Planning Commission Staff Report

Project Type: Sign Package

Description: **Chesterfield Blue Valley:** A request for an Amended Sign Package for Lots 1, 3, 4, and 5 of the Chesterfield Blue Valley development to modify the permitted construction timeframe for one (1) previously approved specialty monument sign.

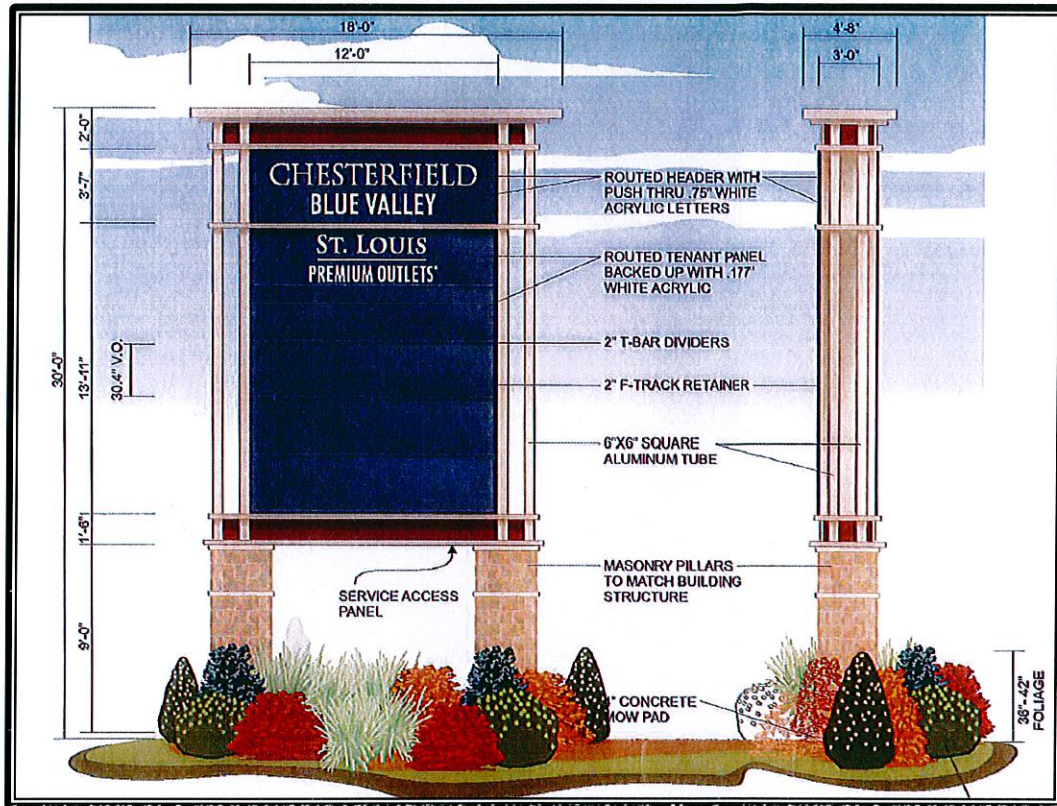
The proposed amendment to the Sign Package proposes one change to the previously approved Sign Package. The approval for the Sign Package for Lot 2 (St. Louis Premium Outlets) permits the construction of three specialty monument signs at locations shown below circled in red. The approved Sign Package for the remainder of Chesterfield Blue Valley (the subject of this request) permits a fourth monument sign to be installed with a future phase of the development of Chesterfield Blue Valley. This location is shown in blue below. The approved sign for this location is shown on the next page. **There are no changes to the size, location, or design of the previously approved sign.** The only change proposed is to allow for the construction of the fourth sign (location shown in blue) with the other three signs, and prior to the construction of the roadway into the Chesterfield Blue Valley development.

The only proposed change is to remove one sentence from page 5, section X. of the narrative statement that states: "The sign at Premium Street will not be constructed until a future phase of the CBV development." All other aspects of the previously approved Sign Package are identical and no other changes are proposed.

After reviewing the proposed Amended Sign Package for Chesterfield Blue Valley, Staff has concern that there is no guarantee of the timing or final construction of the proposed roadway where the sign is proposed. The guarantee and construction of this roadway will be required with future plats through the subdivision process; however, timing of these future improvements is not known at this time.

Based on the concerns noted within this report, Staff believes the original approval to allow the construction of the fourth specialty monument sign to be installed with the future roadway is an appropriate trigger to maintain the purpose of the City’s sign regulations and **Staff does not support the proposed amendment.**
